**LEGAL ADVERTISEMENT
PORTLAND PLANNING BOARD MEETING**

To: Elizabeth Boepple, Chair, and Members of the Portland Planning Board
From: Shukria Wiar, Planner
Date: January 13, 2017
Re: 161 York Street
Project #: 2016-261 **CBL:** 044 B 006
Meeting Date: January 17, 2017

York Street Development LLC has requested a preliminary Level III site plan and subdivision review of an eleven-unit urban infill development at 161 York Street near the Casco Bay Bridge and State Street. The proposed 11,046 SF development includes a five-story multifamily building with parking at two different levels, as well as surface parking spaces. The site will be accessed from York Street and Guilford Court. The vacant lot was previously occupied by two 2-story residential buildings that have recently been demolished. The site is within the R-6 zone and within 100 feet of the West End Historic District.

Attachment A: Pre-Development Watershed Map
Attachment B: Post-Development Watershed Map
Attachment C: HydroCAD Calculations
Attachment D: Soils Map

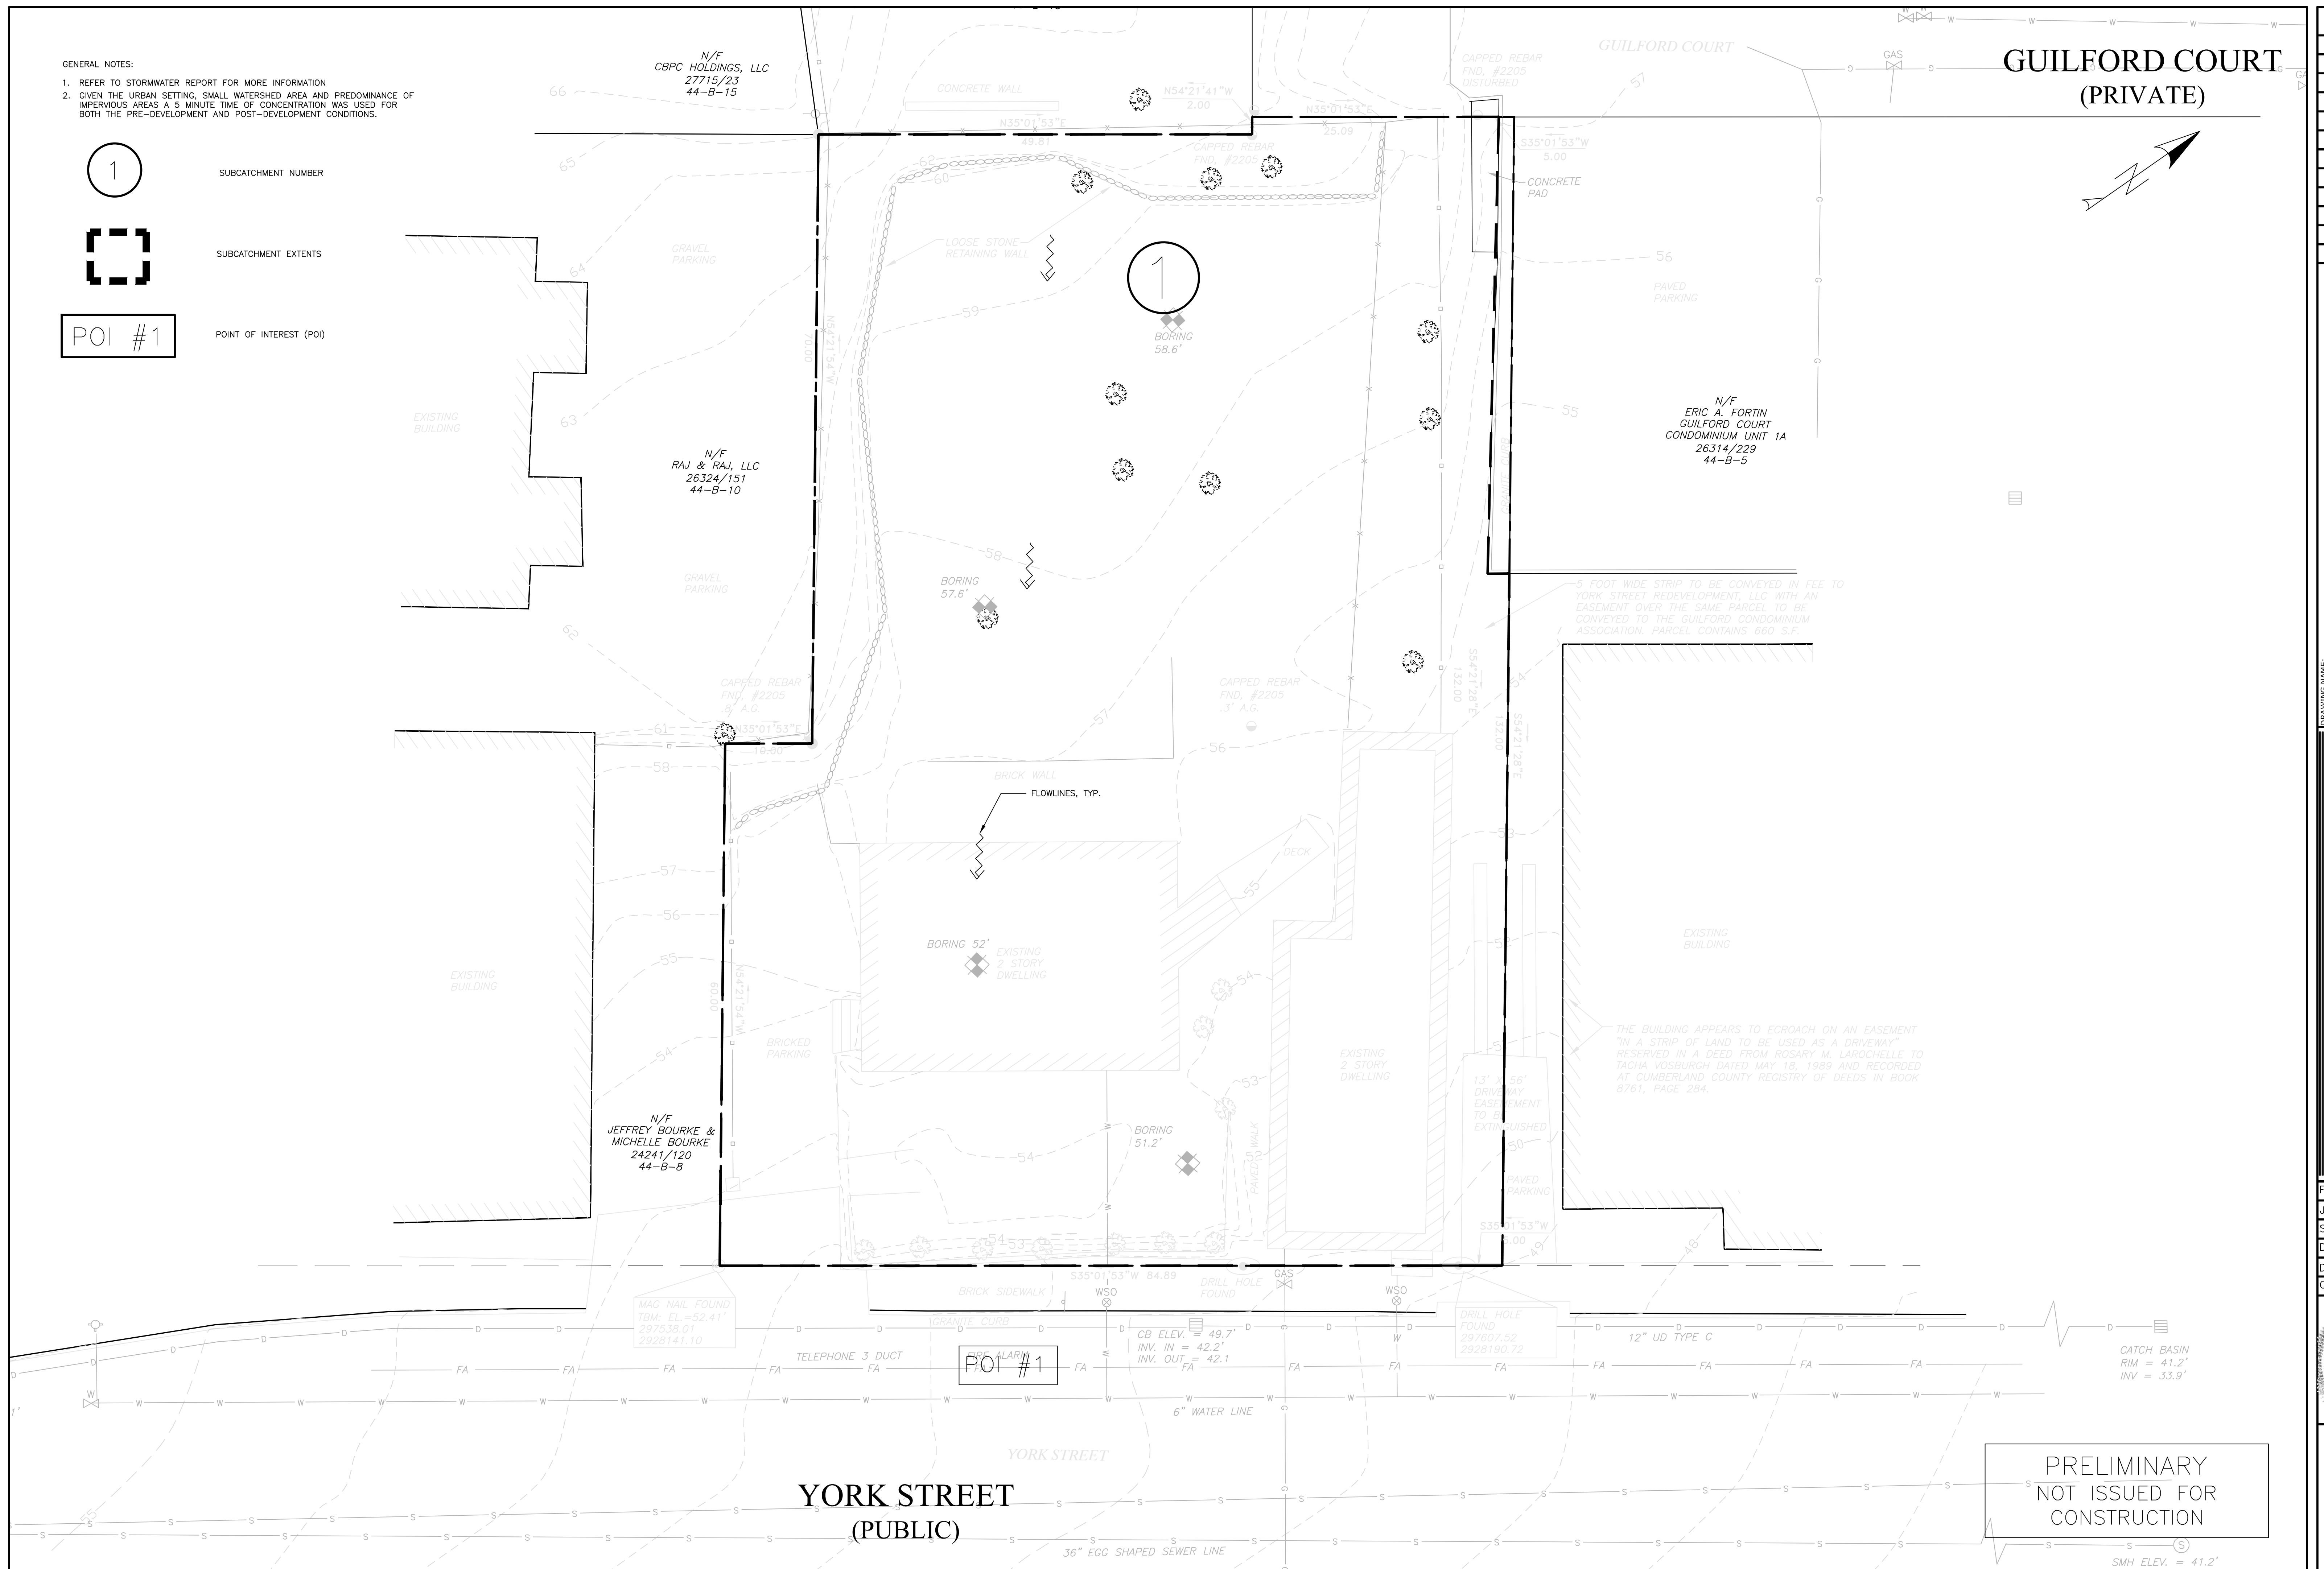
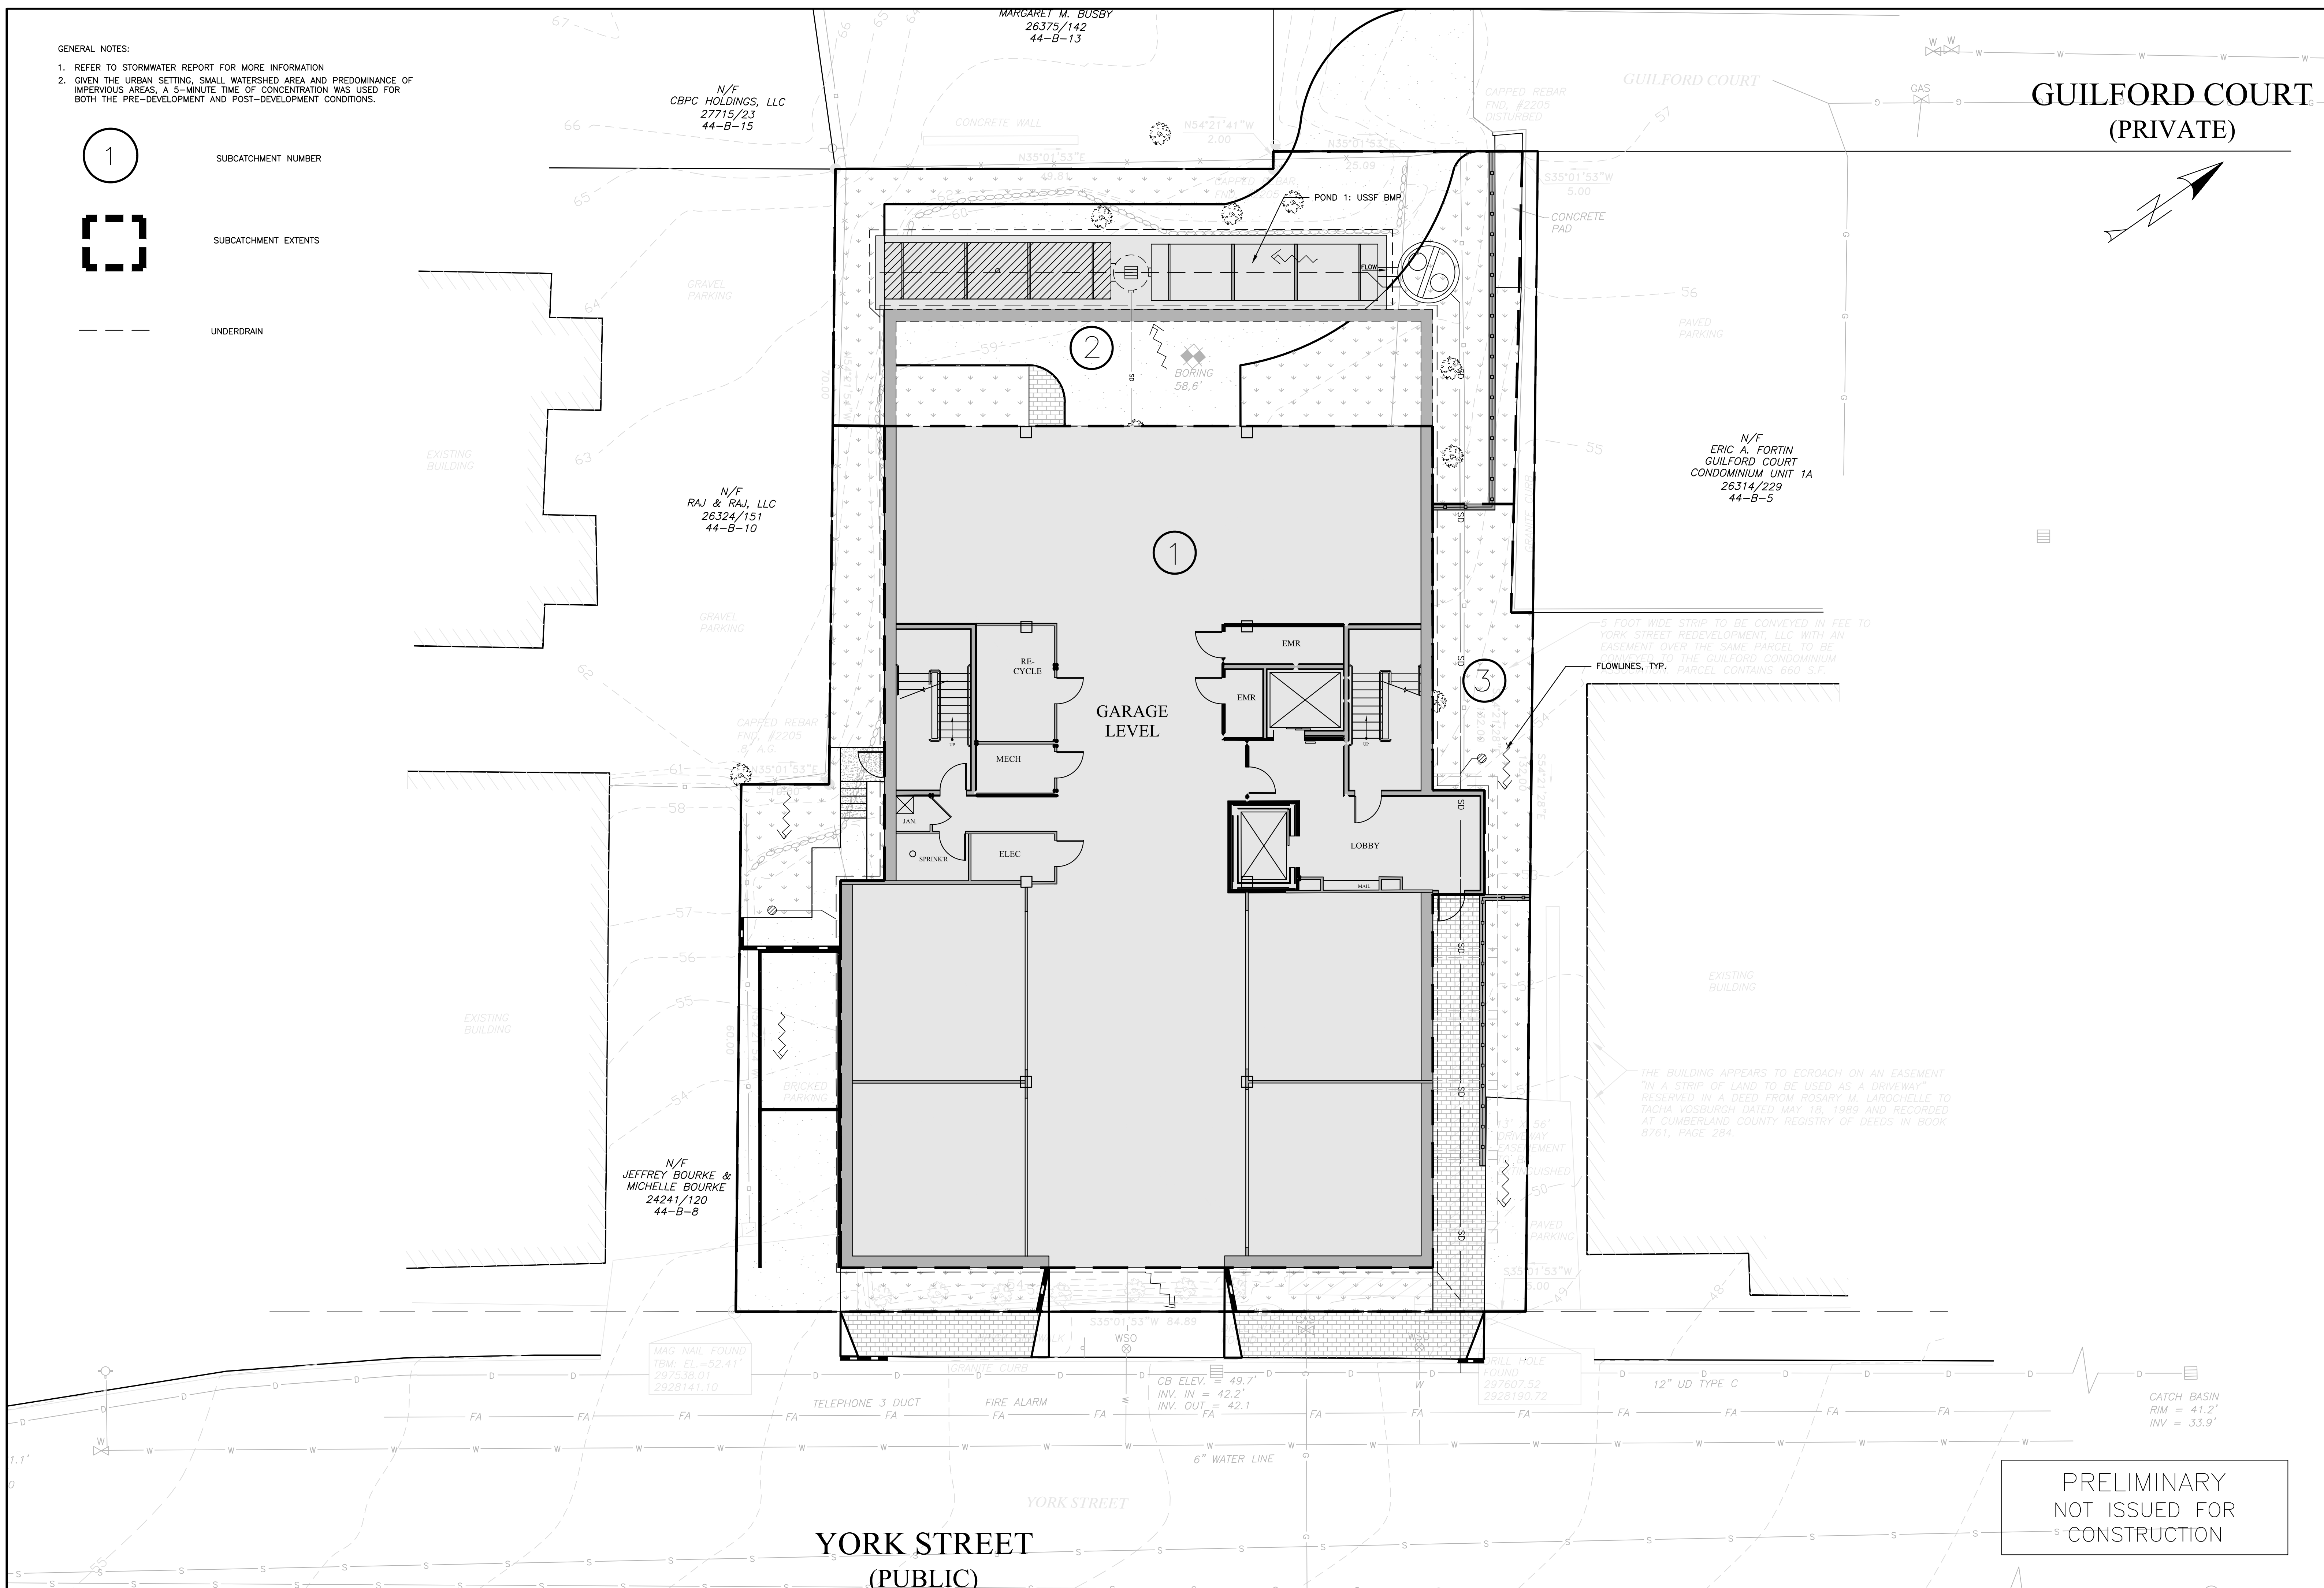
- *The Applicant has utilized a direct entry of five minutes for the pre-development Time of Concentration; however, given the gradual slopes and pervious nature of the existing site, the Applicant should calculate a Time of Concentration and verify whether it exceeds five minutes.*
